Technical Update

Issue Number: **TU459**
Author: **J. Sidaway**
Page: **1 of 2**
Issue Date: **10 / 03 / 11**
Valid Period: **N/A**

Product Description:	C & E SERIES WIDESCREEN MULTI FUNCTION DISPLAY(S)
Product Code(s):	E62111 / E62113 / E62115 / E62220 / E62223 / E62226
Effective Start Date:	➤ 0700001 : JUNE 2010
Subject:	CHART DOOR / HINGE MODIFICATION

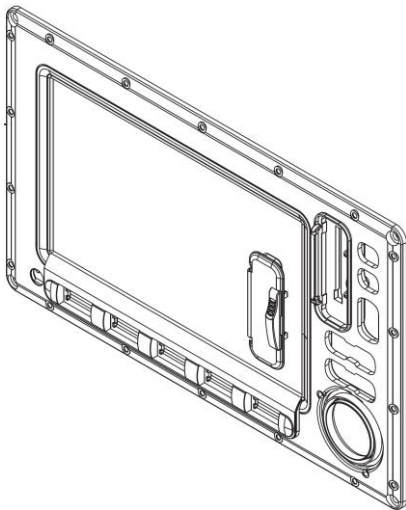
The existing chart door had a chamfer in the hinge area as illustrated in **FIGURE A**, in order to allow unrestricted opening of the chart door, the chamfer can be easily removed by using a sharp blade to create a hinge area as illustrated in **FIGURE B**.

Therefore, a proposed solution is to remove a section from the hinge area in the chart door to relieve the interference and allow unrestricted opening of the chart door with the clip-on front bezel installed.

Please note if the situation arises that the chart door on the C or E Series Widescreen display unit is found that the hinge area of the front panel has not been damaged and a previous chart door is in place, Raymarine encourage for the above modification to be employed to prevent future mechanical failure due to customer mis-handling.
